STATE OF CALIFORNIA - DEPARTMENT OF TRANSPORTATION
Caltrans

CONTRACT CHANGE ORDER No. 170
 SHEET _____ OF _____

**ROADWAY LIGHTING POLE
 PLAN LOCATION-SHEET 24
 SKYWAY STRUCTURES**
 NO SCALE

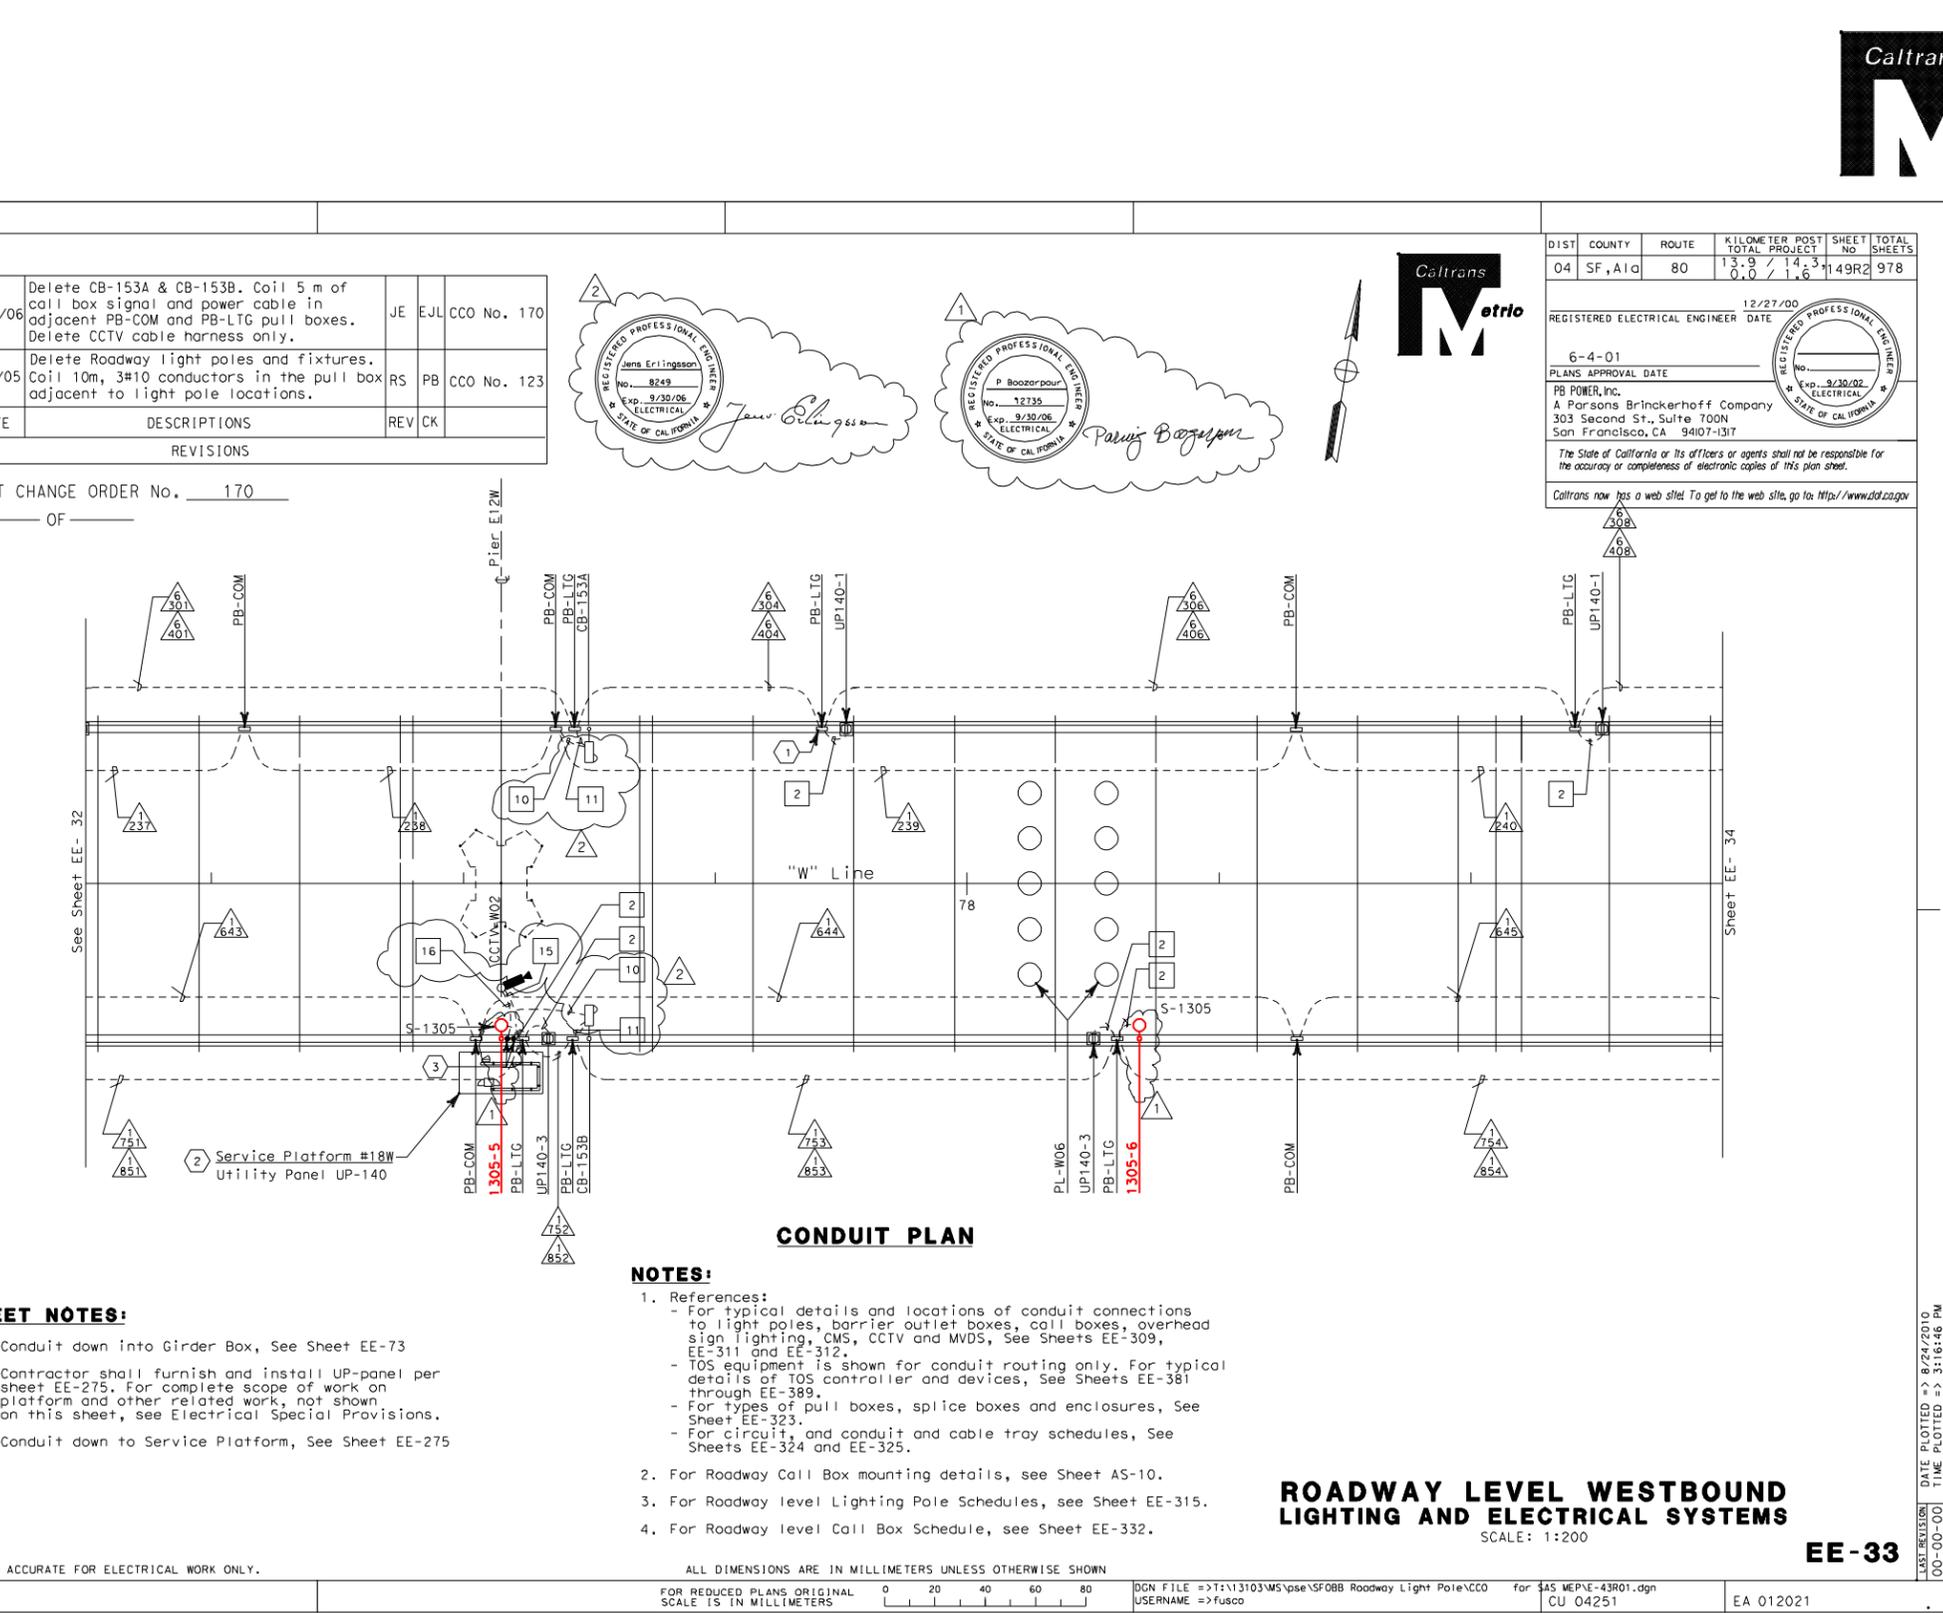
MARK	DATE	DESCRIPTIONS	REV	CK
2	1/20/06	Delete CB-153A & CB-153B. Coil 5 m of call box signal and power cable in adjacent PB-COM and PB-LTG pull boxes. Delete CCTV cable harness only.	JE	EJL CCO No. 170
1	3/2/05	Delete Roadway light poles and fixtures. Coil 10m, 3#10 conductors in the pull box adjacent to light pole locations.	RS	PB CCO No. 123
